BOARD OF COUNTY COMMISSIONERS
ORANGE COUNTY, FLORIDA

ADDENDUM NO. 3 / IFB NO. Y18-758-TA

SOUTH SERVICE AREA/EAST SERVICE AREA (SSA/ESA) 36-INCH POTABLE
WATER MAIN, 24-INCH RECLAIMED WATER MAIN AND J. LAWSON BLVD
POTABLE WATER RE-PUMP FACILITY

SCALE: AS SHOWN
 DRAWING NO.:
A1.0
 SHEET: 152 OF 292

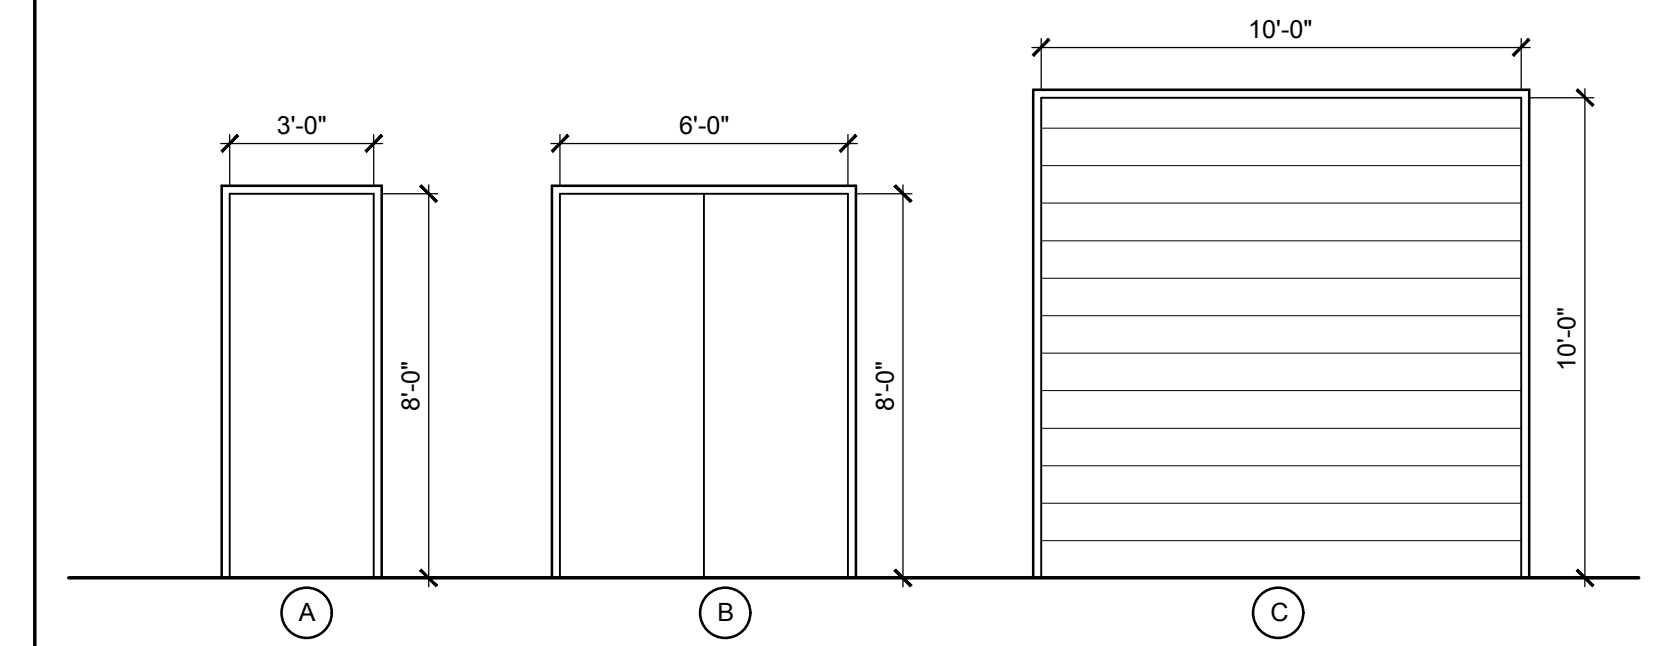
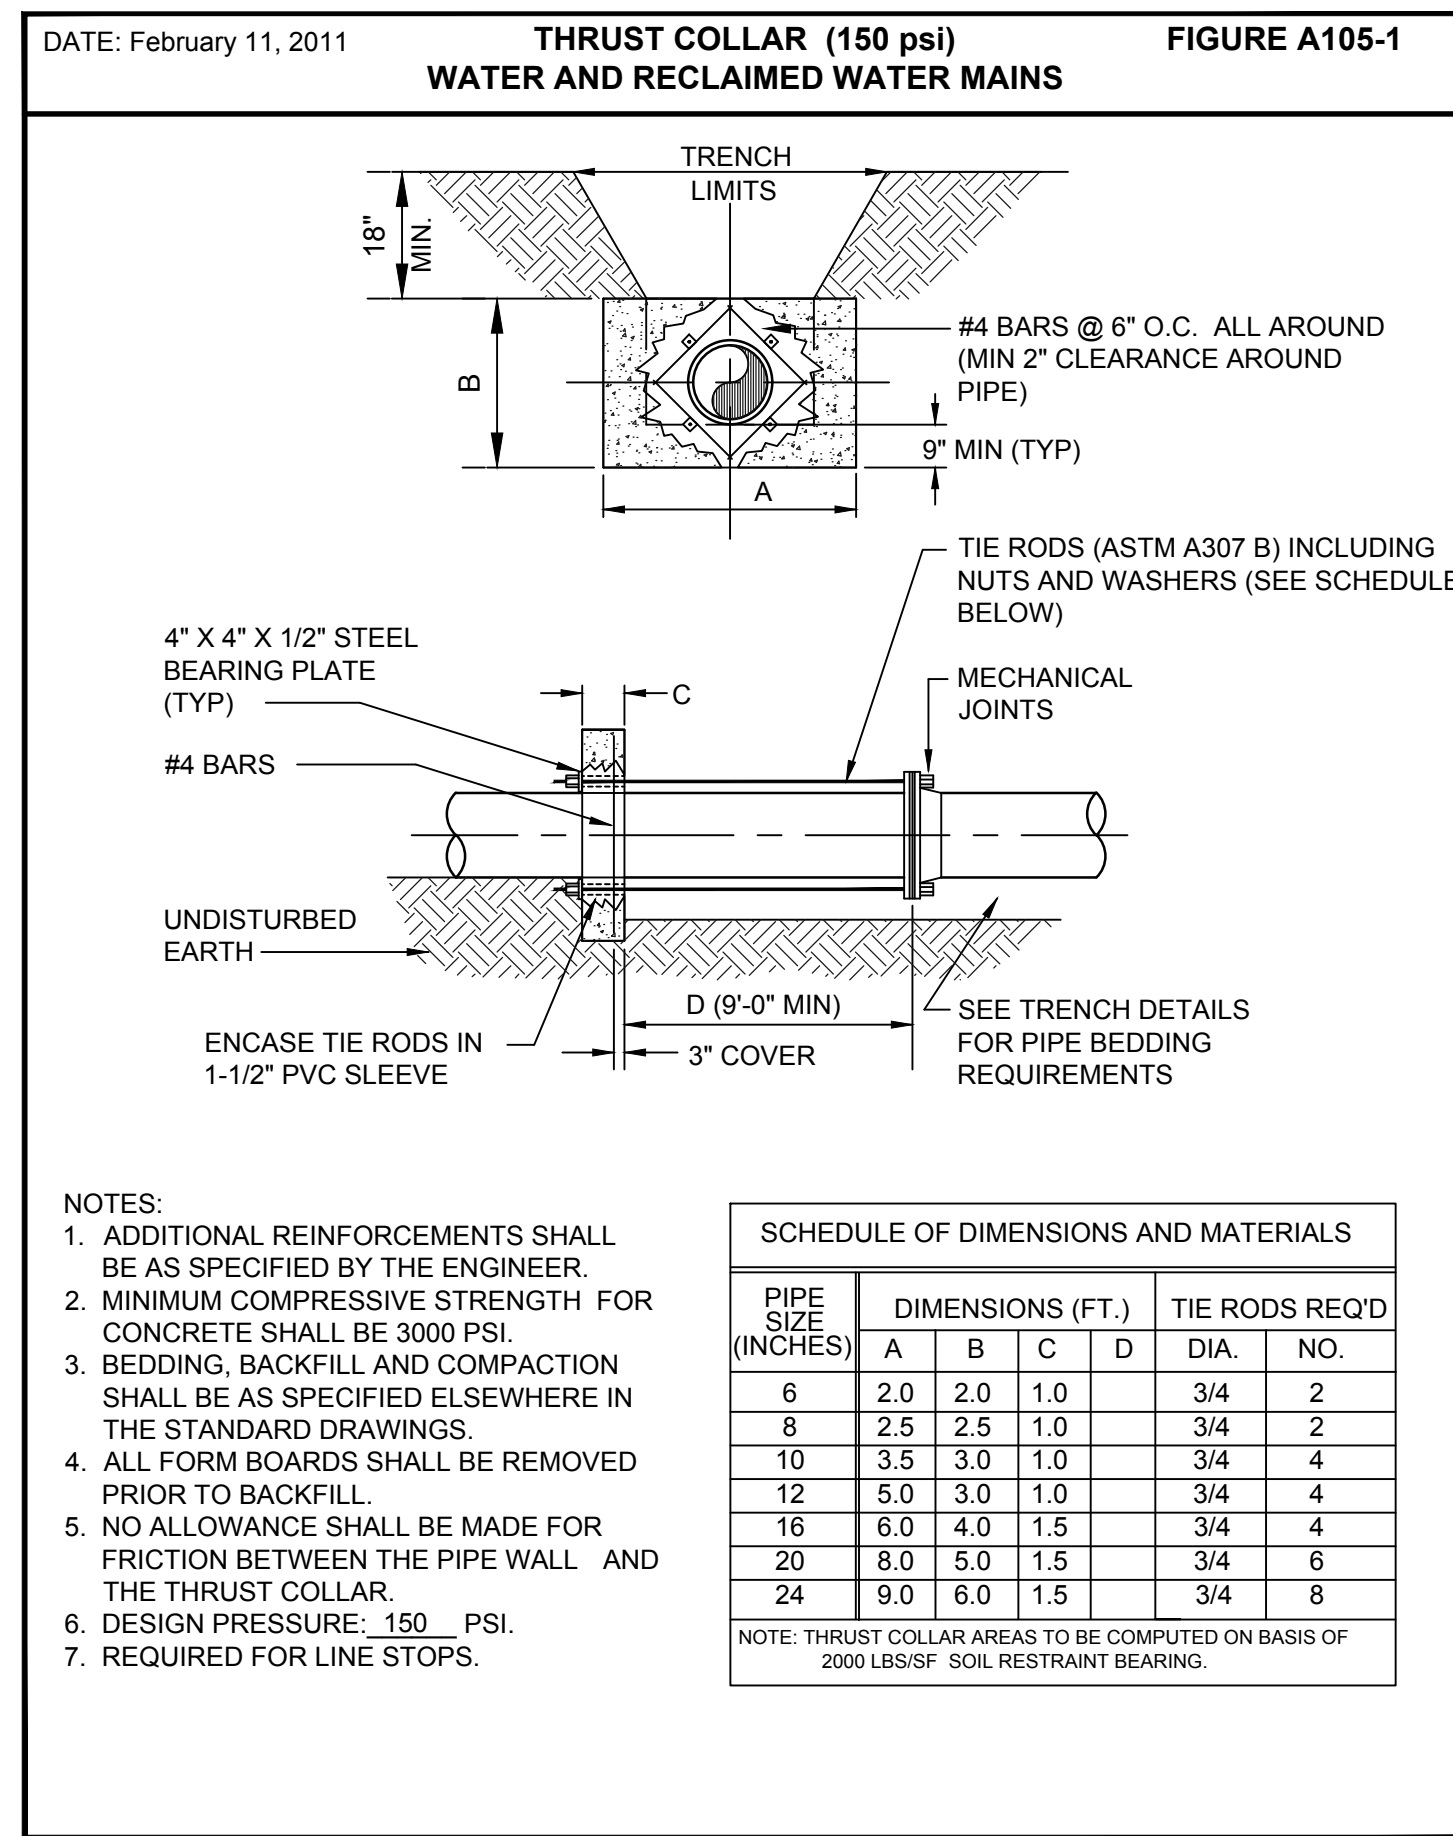
DRAWING A1.0, E-07, and E-10

Amend: Delete drawings A1.0, E-07, and E-10 and replace with the revised drawings A1.0, E-07, and E-10. The revised drawings show the overhead door 103B on A1.0 being electrically operated and power running to the overhead door.
